The amendment revises TS Sections 6.2 and 6.3 which pertain to the plant operating shift organization and qualifications.

JAMES A. FITZPATRICK NUCLEAR POWER PLANT

Amendment No. 111
License No. DPR-59

SAFETY EVALUATION BY THE OFFICE OF NUCLEAR REACTOR REGULATION
RELATED TO AMENDMENT NO. 111 TO FACILITY OPERATING LICENSE NO. DPR-59
POWER AUTHORITY OF THE STATE OF NEW YORK
JAMES A. FITZPATRICK NUCLEAR POWER PLANT
DOCKET NO. 50-333

FIGURE 6.2-1

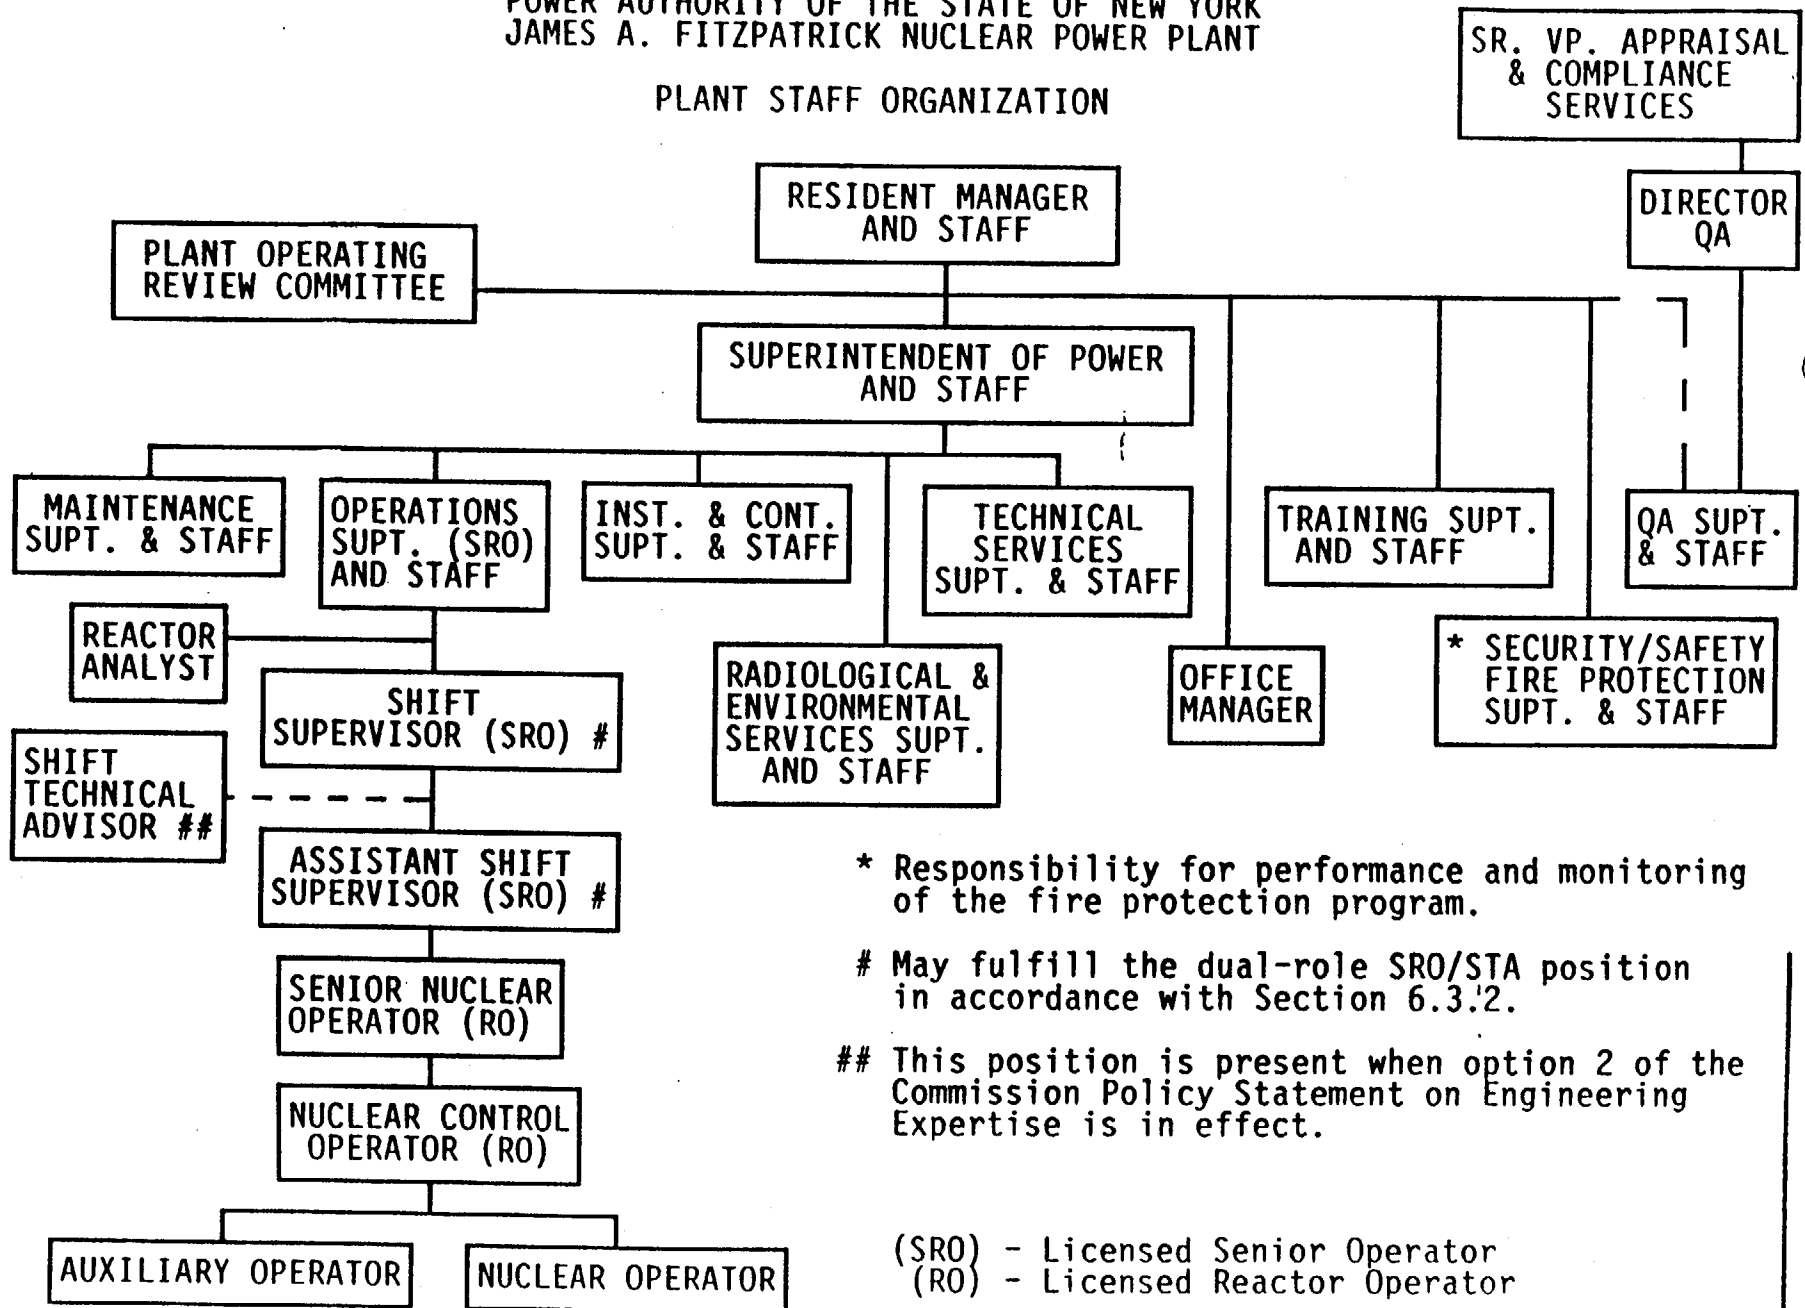
Figure 6.2-1 has been revised to add a second SRO (Assistant Shift Supervisor) to the shift staff in order to incorporate previous licensee commitments to meet NUREG-0737 requirements. In addition, two notes have been included in Figure 6.2-1. The one pound sign indicates that either the Shift Supervisor or Assistant Shift Supervisor may be a dual-role SRO/STA in accordance with Section 6.3.2. The two pound sign indicates that the STA position is present only when option 2 of the Commission Policy Statement on Engineering Expertise on Shift is in effect.

These revisions are acceptable for they reflect the changes described and accepted in Section 6.2 and Section 6.3 of this Safety Evaluation.
